To:	Valmichael Leos and Anne Foster, USEPA	Date:	February 21, 2014
From:	Wendell Mears, Randy Brown, David Keith, John Verduin, and John Laplante	Project:	090557-01.04
Cc:	Dave Moreira and Andrew Shafer, MIMC Phil Slowiak, IP		
Re:	San Jacinto River Waste Pits TCRA Armored Cap Enhancement Completion Report

Re: Armored Cap Enhancement Work Plan
San Jacinto River Waste Pits Superfund Site Time Critical Removal Action United
States Environmental Protection Agency, Region 6, CERCLA Docket No. 06-12-10

Re: San Jacinto River Waste Pits Superfund Site Time Critical Removal Action
Response to USEPA Questions on TCRA Cap Assessment
CERCLA Docket No. 06-12-10

Figure 1
Gradation of Armor Rock B/C
San Jacinto River Waste Pits Time Critical Removal Action

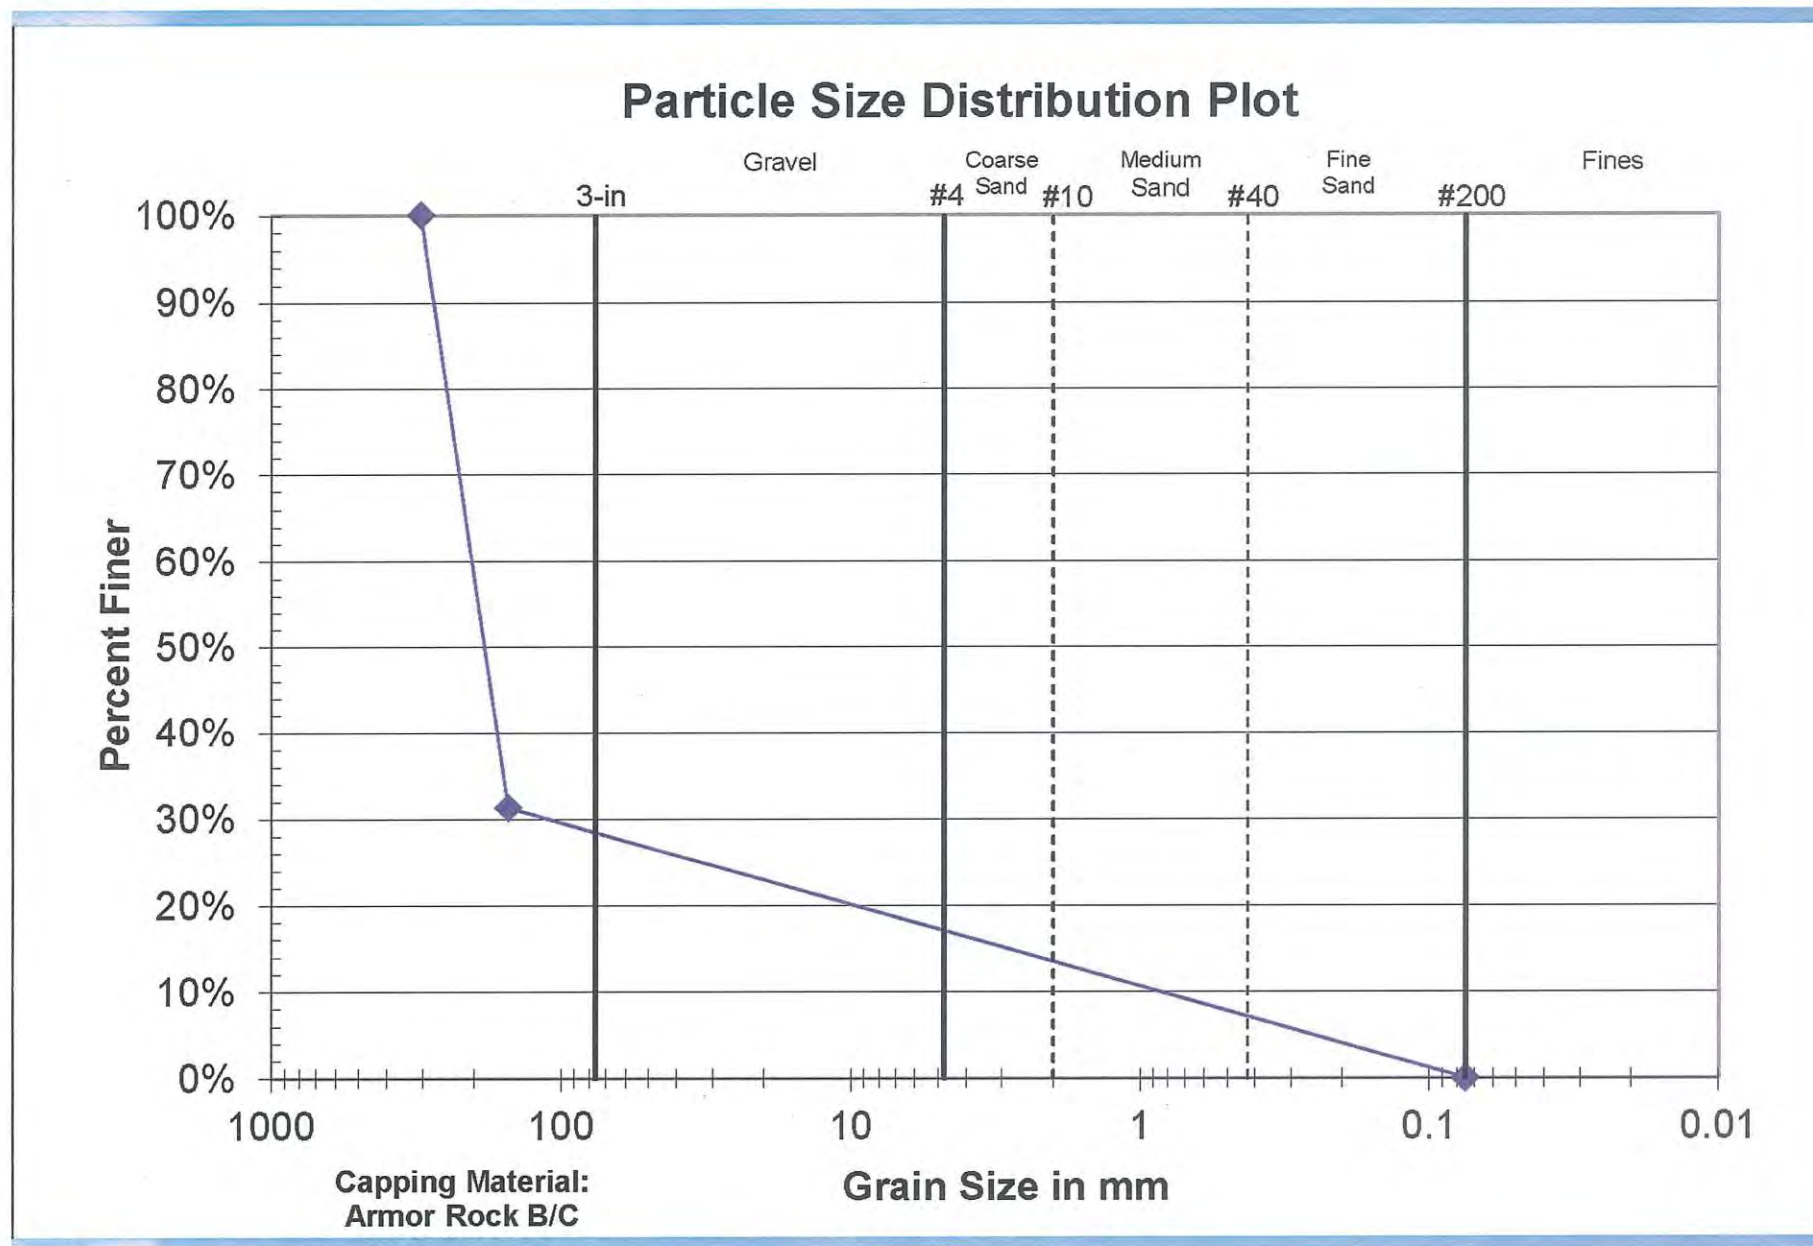
2. What is the measured or estimated grain size distribution for the B/C armor material?
Specifically, what are the

- a. D_{100}
- b. D_{85}
- c. D_{60}
- d. D_{50}
- e. D_{15}
- f. D_{10}
- g. D_{30}

Using the contractor gradation submittal for the B/C armor material, the following is the measured and estimated grain size distribution for this material:

- D_{100} 12 inches
- D_{85} 9 inches
- D_{60} 8 inches
- D_{50} 6 inches
- D_{30} 4 inches
- D_{15} 0.12 inches
- D_{10} 0.033 inches

A grain size distribution curve for this material is attached for reference.
